**ADDENDUM NO. 2**

**Scruggs Stations Warehouse**
**Complex Porite Roof Electrical & HVAC Repairs**
**Fairgrounds Warehouse**
**Jefferson City, MO**
**PROJECT No.: O2534-01**

**October 30, 2026 *issued date**

SHEET TITLE:
DEMO MECHANICAL & ELECTRICAL PLAN - SECOND FLOOR

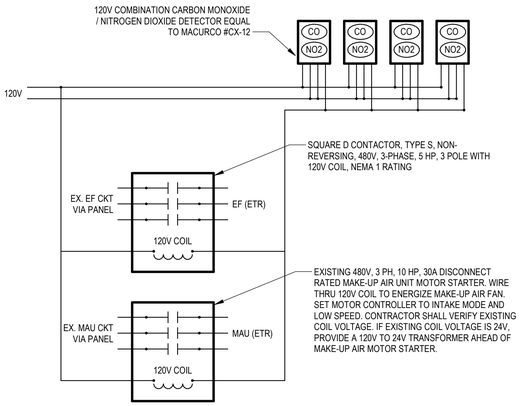
1. Drawing MED200 – DEMO MECHANICAL & ELECTRICAL PLAN - SECOND FLOOR

a. ADD: Existing location of mezzanine electrical panel.

SHEET TITLE:
MECHANICAL & ELECTRICAL PLAN - FIRST FLOOR

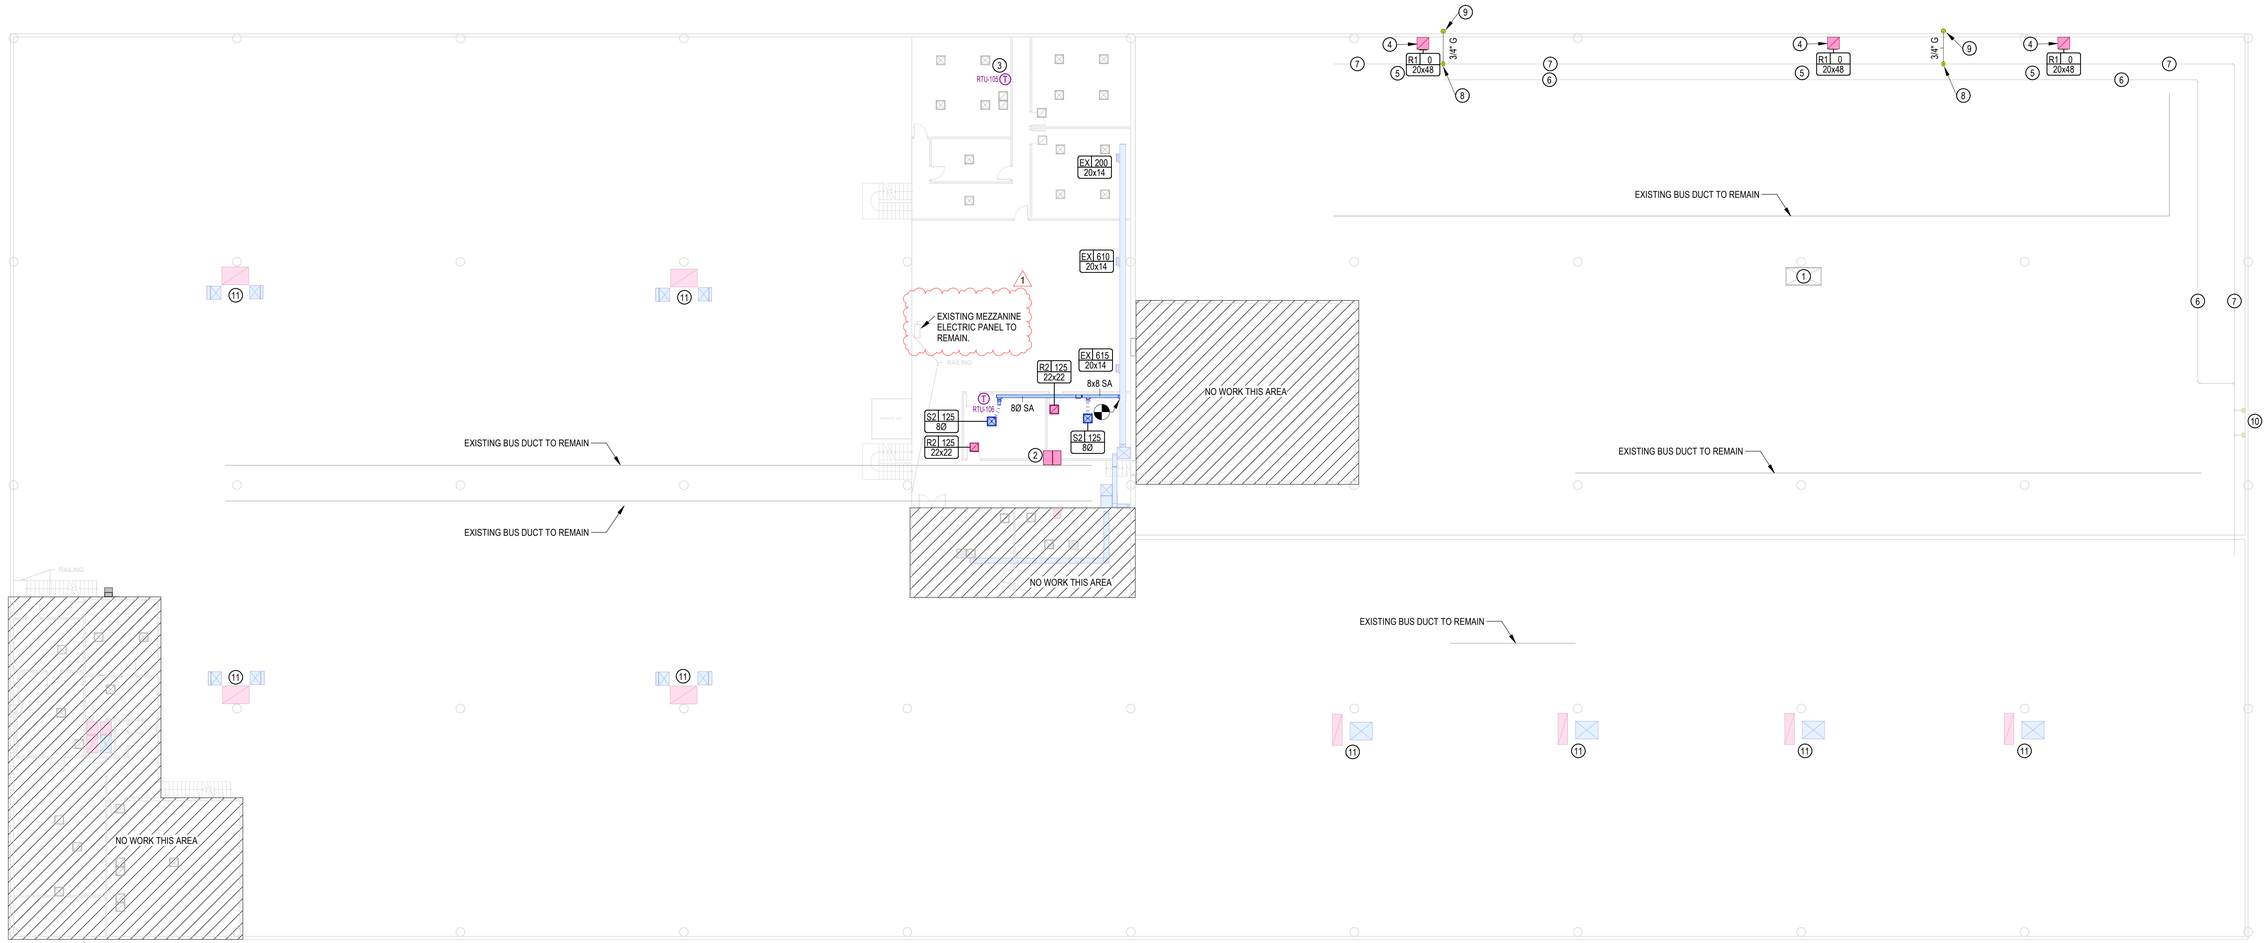
2. Drawing ME100 – MECHANICAL & ELECTRICAL PLAN - FIRST FLOOR
    a. REVISE: General note #5.
    b. ADD: General note #6

4. ALL ELECTRICAL TAGGED EX. OR ETR SHALL BE EXISTING TO REMAIN UNLESS NOTED OTHERWISE.
5. CONTRACTOR IS RESPONSIBLE FOR FIELD VERIFYING SIZE OF EXISTING UNITS AND CURBS PRIOR TO ORDERING MATERIALS OF ROUGH-INS. CURB SIZES NOTED ON PLANS ARE APPROXIMATE AND NEED CONTRACTOR FIELD VERIFICATION. CONTRACTOR IS RESPONSIBLE FOR ANY STRUCTURAL MODIFICATIONS OR REINFORCEMENT REQUIRED.

SHEET TITLE:
MECHANICAL & ELECTRICAL PLAN - ROOF

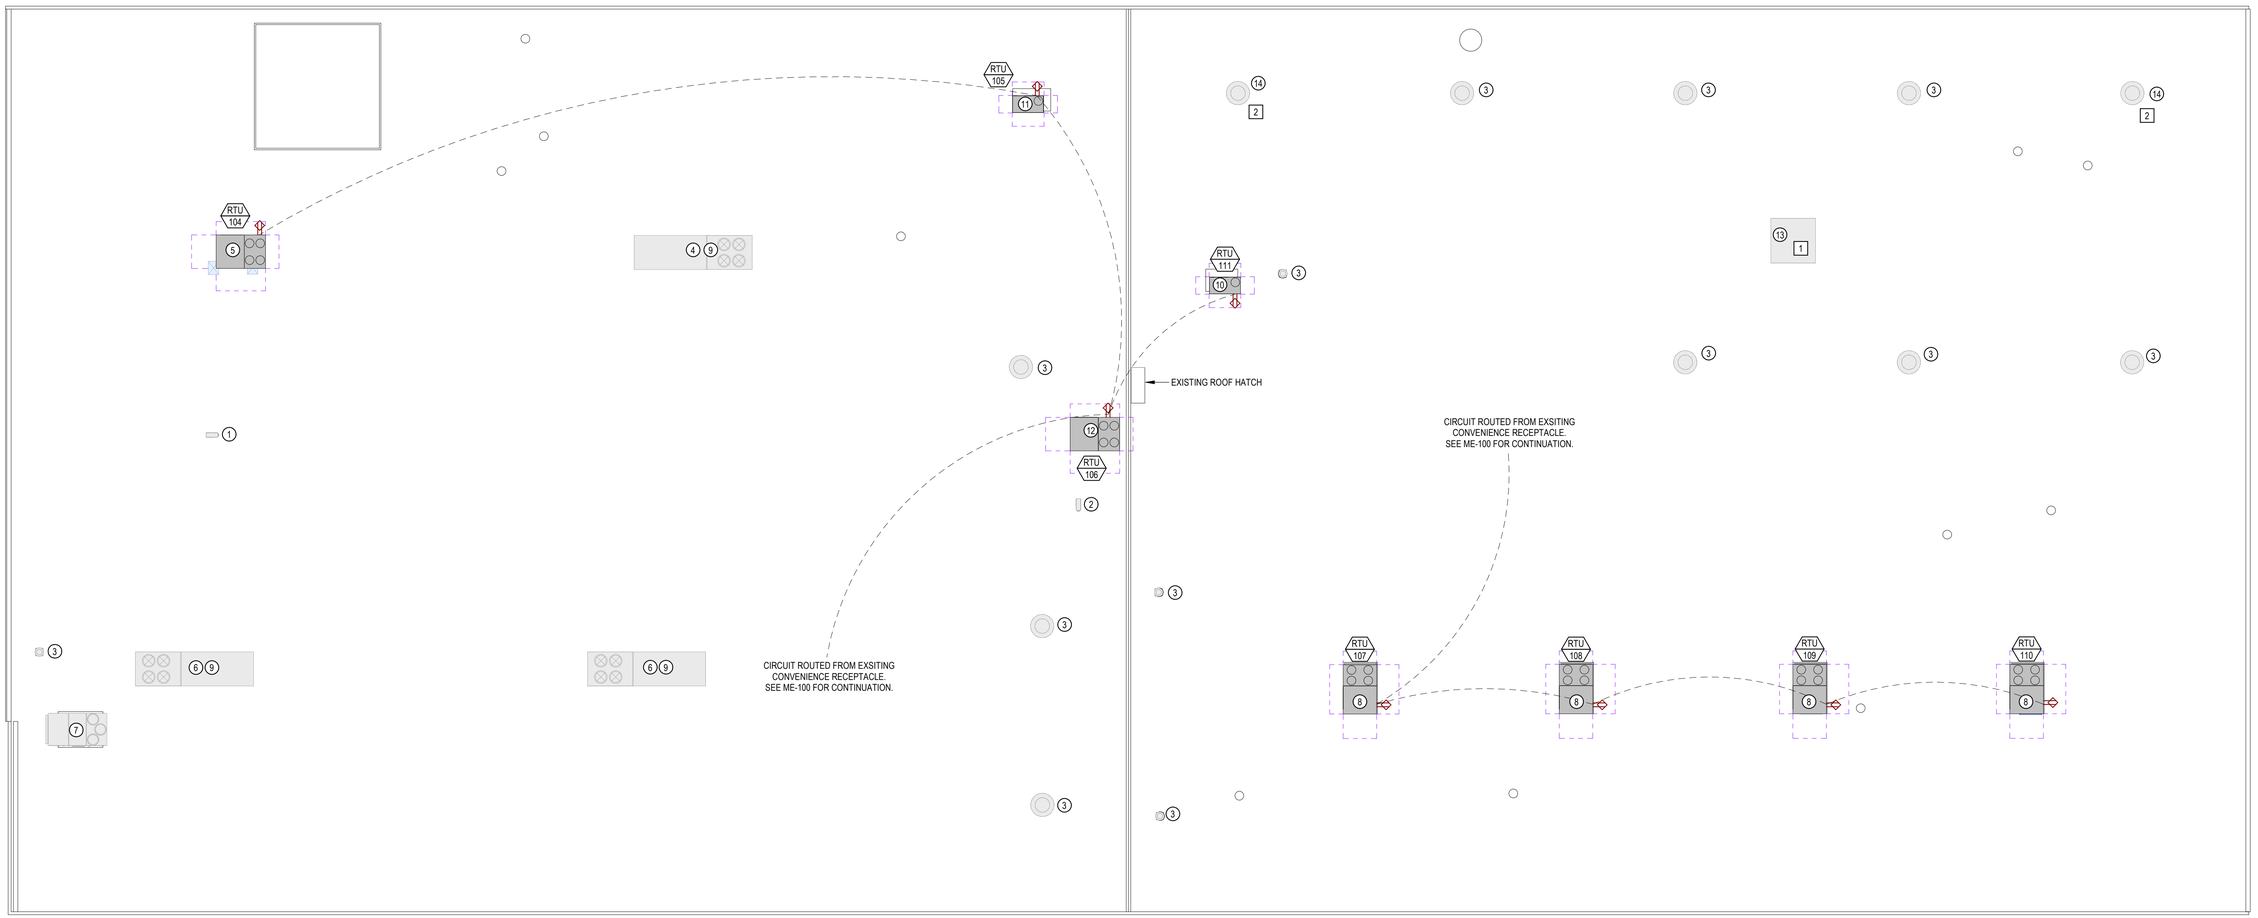
4. Drawing ME300 – MECHANICAL & ELECTRICAL PLAN - ROOF
   a. REVISE: General note #5.
   b. ADD: General note #6
   c. REVISE: Key notes 5, 10, 11, 12

9. REBALANCE OUTSIDE AIR OF EXISTING RTU TO BE 1,550 CFM
10. PROVIDE CURB ADAPTER TO BE INSTALLED ON EXISTING CURB. EXISTING CURB DIMENSIONS 82x62x8". EXTEND CONDUIT/CONDUCTORS THRU SIDE OF EXISTING CURB TO NEW DISCONNECT.EXTEND CONDUIT / CONDUCTORS TO NEW RTU ELECTRICAL CONNECTION LOCATION. REPLACE EXISTING BREAKER IN MEZZANINE PANEL (SHOWN ON ME200) WITH NEW BREAKER SIZED PER RTU SCHEDULE MOP.

11. PROVIDE CURB ADAPTER TO BE INSTALLED ON EXISTING CURB. EXISTING CURB DIMENSIONS 92x63x8". EXTEND CONDUIT/CONDUCTORS THRU SIDE OF EXISTING CURB TO NEW DISCONNECT.EXTEND CONDUIT / CONDUCTORS TO NEW RTU ELECTRICAL CONNECTION LOCATION. REPLACE EXISTING BREAKER IN MEZZANINE PANEL (SHOWN ON ME200) WITH NEW BREAKER SIZED PER RTU SCHEDULE MOP.

12. PROVIDE CURB ADAPTER TO BE INSTALLED ON EXISTING CURB. EXISTING CURB DIMENSIONS 265x96x16". EXTEND CONDUIT/CONDUCTORS THRU SIDE OF EXISTING CURB TO NEW DISCONNECT.EXTEND CONDUIT / CONDUCTORS TO NEW RTU ELECTRICAL CONNECTION LOCATION. REPLACE EXISTING BREAKER IN MEZZANINE PANEL (SHOWN ON ME200) WITH NEW BREAKER SIZED PER RTU SCHEDULE MOP.
